**UK proposal test procedure (ACPE-09-06)
concern and clarification**

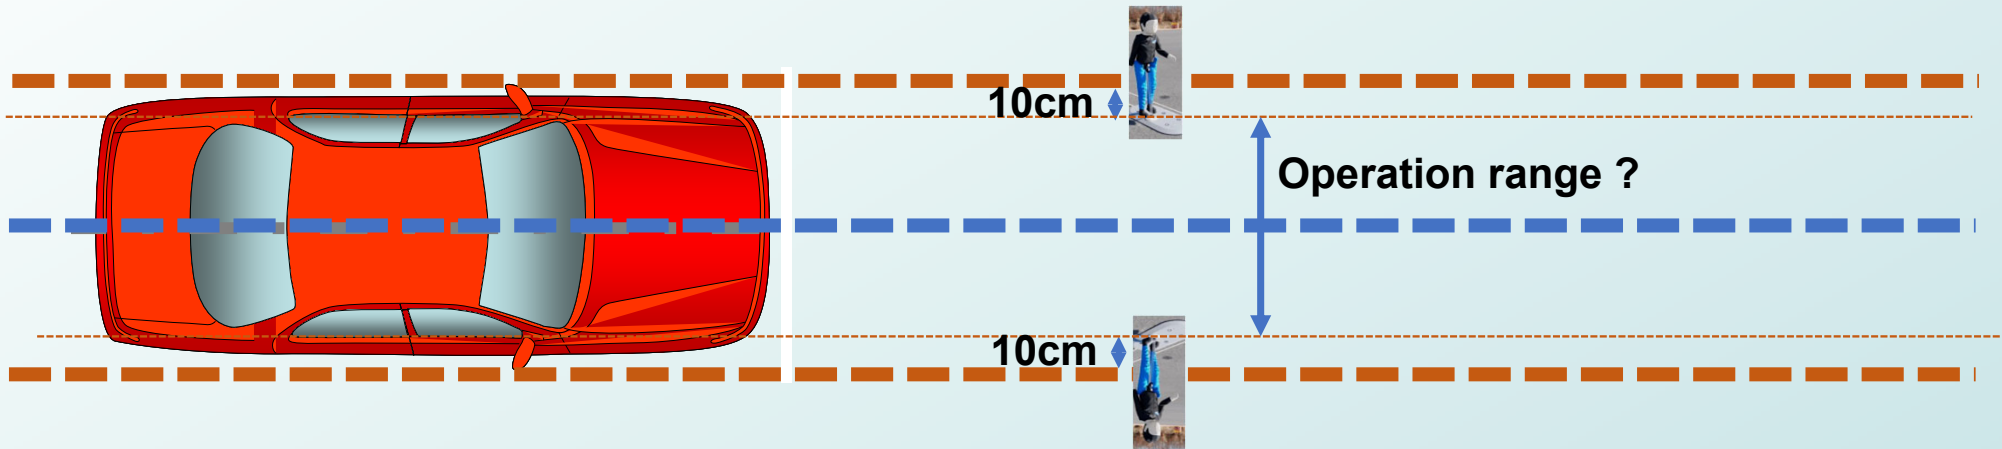
How to treat "Wall" ?

It is hard to detect pedestrian robustly by Sonar sensor.

■ Detection of Sonar sensor

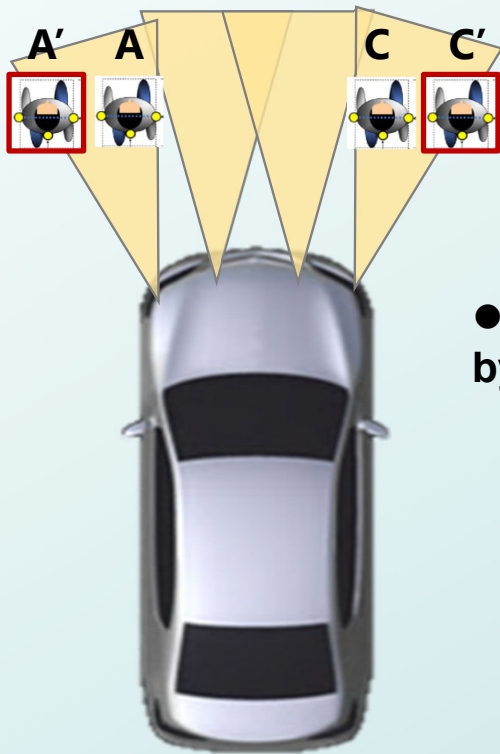
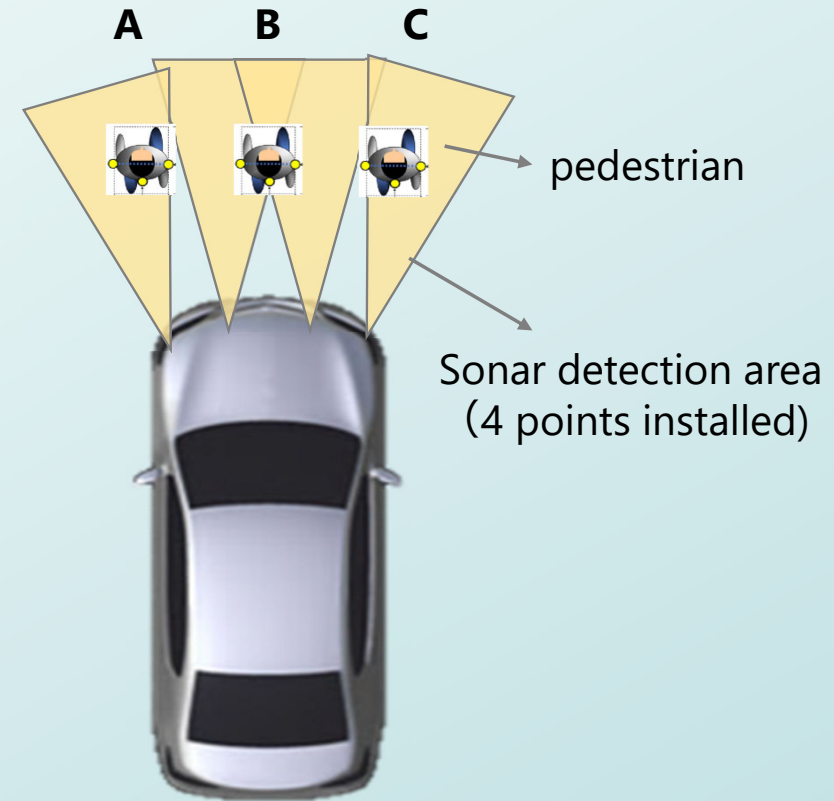
- Sonar sensor does not have lateral resolution.
- Using two sonar sensors data, system decide it's position.
- To avoid false positive, with sonar, objects detected by two sensors are determined to be targets. (Ensuring detection reliability)
- Regarding objects located at the edge of the vehicle, such as A and C, detection reliability cannot be ensured with just one sensor, and it is not possible to determine whether the object should be activated.

- We can't distinguish between A and A' by one sonar detection data.

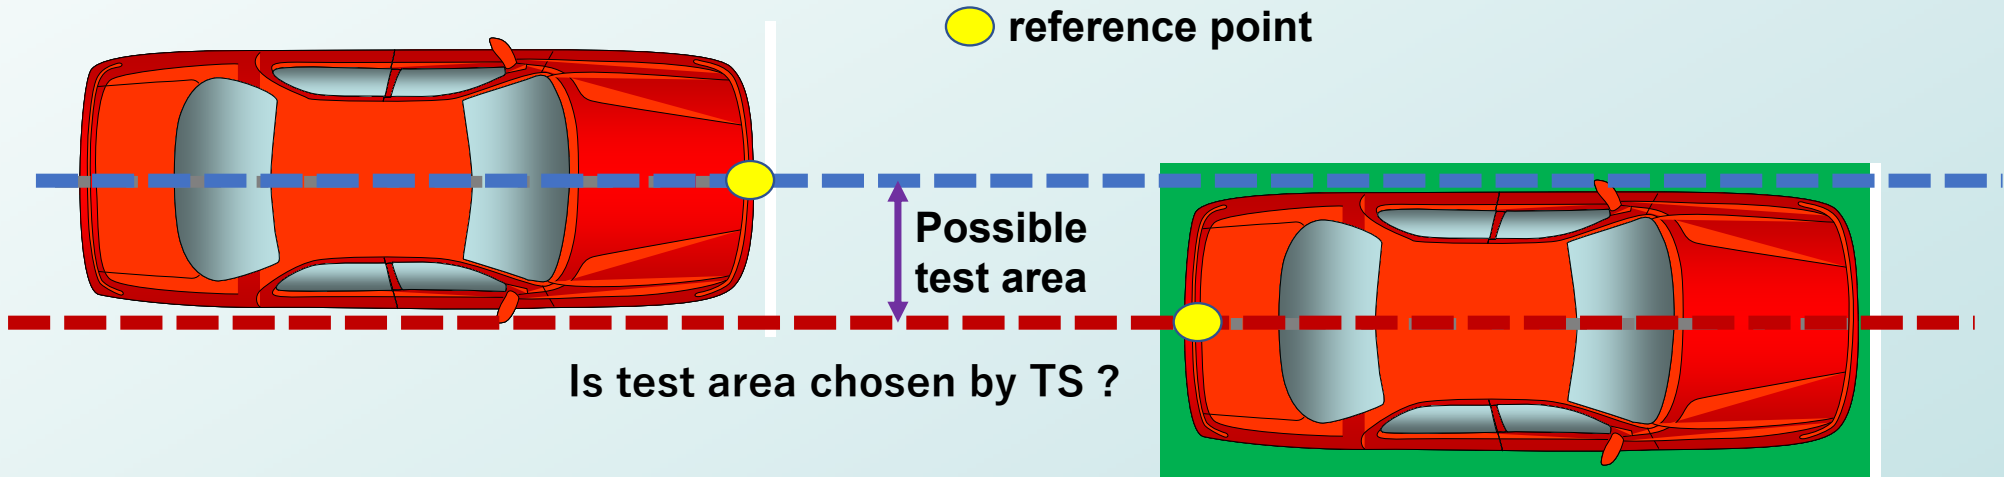
■ wall

- Operation to wall is a scope, but not test in the test section in 00 series.
- 6.5.2 means “to conduct Wall test” ?

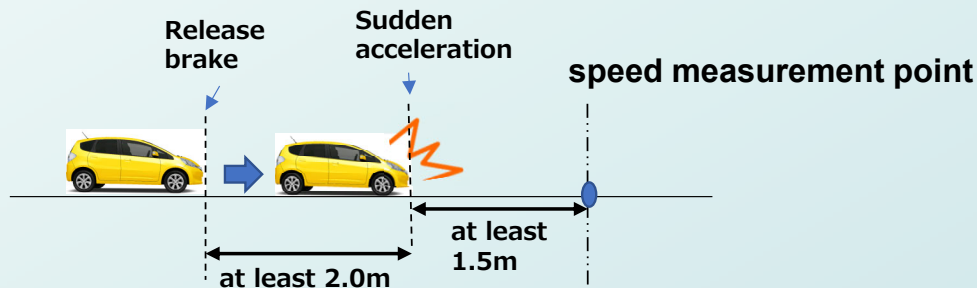
- steady state creep speed : How to define “steady state creep speed” ?
(→ see next slide)

■ Propose

“creeping steady state”, → “creeping off” and apply a max. duration of 2s and max. speed of 4 km/h

■ 1. Creeping speed profile (11 models, 20 data)

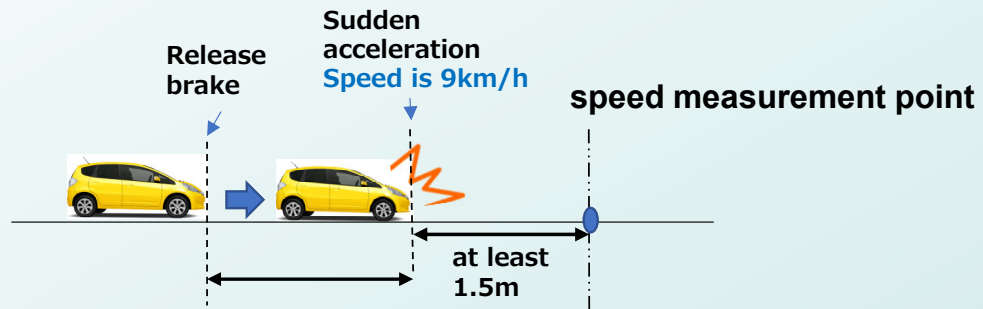
There is a vehicle whose creep speed exceeds 10 km/h.

Some OEMs **operate AEB to very low speeds.**
For example, 3km/h.

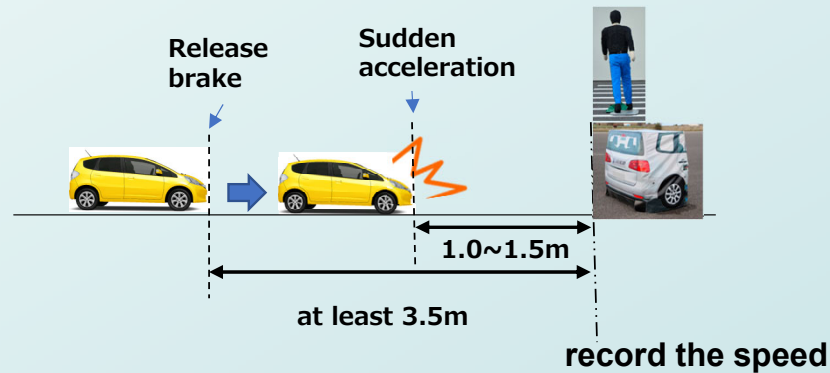
- **No obstacle situation**

6.7.2.4 mentioned “at least 1.5m” = distance is 1.5m or more

- **Presence of obstacle**

6.7.3.3~6.7.3.4 mentioned : accelerator input “between 1~1.5m” = distance is below 1.5m

- **How to compare the speed with and without ACPE function ?**
